Dethatching Reel Cover Plate Interference

Product: Reelmaster® 4000

October 26, 2010

Subject: A hydraulic fitting on the Reel Motor contacts the Front Cover of the Dethatcher

Fig. 1

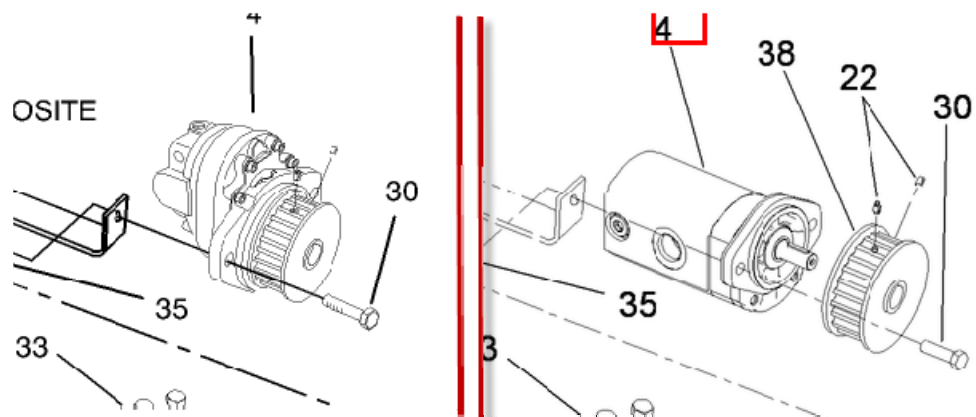
During 2009 as part of our ongoing design improvements, the hydraulic reel motors used on the Reelmaster 4000 (RM 4000) were changed to a different design. When RM 4000 Dethatching Reels are installed on units having these newer-style reel motors, the Front Cover (100-9993) of the Dethatcher will be contacted by the hydraulic fitting of the reel motor (Fig. 1).

Fig. 2

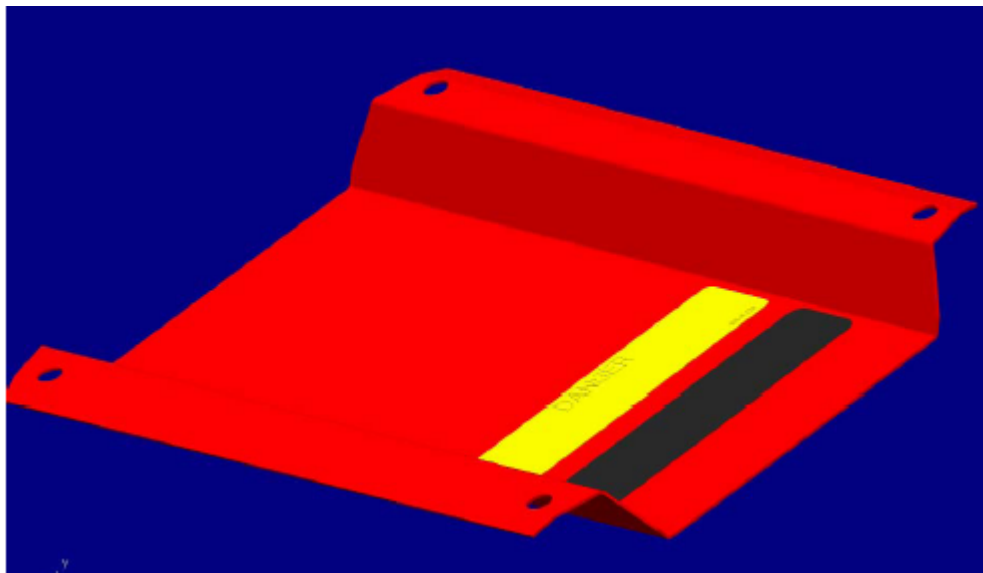
Pre-2009 Reelmaster 4000 traction units that have a hydraulic motor replaced with one of the newer design will experience this interference when Dethatcher units are installed. Fig. 2 shows the difference between the two reel motor designs.
